| DATE: | February 2, 2022 |
| TO: | Portland Planning and Sustainability Commission |
| SUBJECT: | Residential Infill Project—Part 2 Potential Amendments List |

Amend 33.418.030.G:

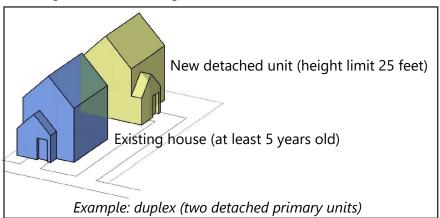
The Planning and Sustainability Commission considered the proposed changes to the constrained sites overlay zone as part of RIP2, including the addition of wildfire risk as a constraint for additional middle housing density. The Commission weighed competing Comprehensive Plan policies relating to housing access and location against limiting development in areas prone to natural hazards. The Commission considered risk from proximity to the wildland urban interface against infrastructure systems to support emergency services and access. Ultimately, the Commission concluded that in general, areas within the higher density R2.5, R5 and R7 zones have higher housing opportunity scores and are proximate to services, jobs, education and amenities and growth in these areas is consistent with the overall city growth strategy. Moreover, these areas have more complete and connected street systems to facilitate evacuation. These factors tipped the scale in favor of removing wildfire as a constraint in these areas, but the Commission chose to continue to apply wildfire risk as a constraint for middle housing development in the lower density R10 and R20 zones. In addition, the Commission discussed adding a recommendation in their transmittal letter to City Council that BPS be directed to update the 'z' overlay zone in the R10 and R20 zones after the State of Oregon's Wildfire Hazard Map is updated.

G. Sites in the R10 and R20 zones with a cumulative hazard value of 5 or more as shown on the 1998 City of Portland Wildfire Hazard Zone map;
